## PRODUCT CHANGE NOTIFICATION

# ICR-4[12]61(W) and ICR-4[12]33(W) Rev.1.1

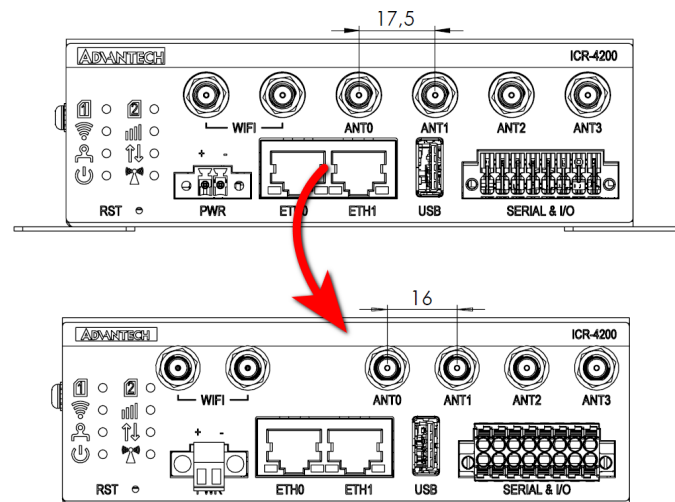
- The housing now has 7 ANT holes instead of 6, with a distance of 16 mm between them instead of 17.5 mm.
- The front panel sticker reflects this change.
- In product versions with fewer than 7 ANT connectors, the extra holes are hidden by the front panel sticker.
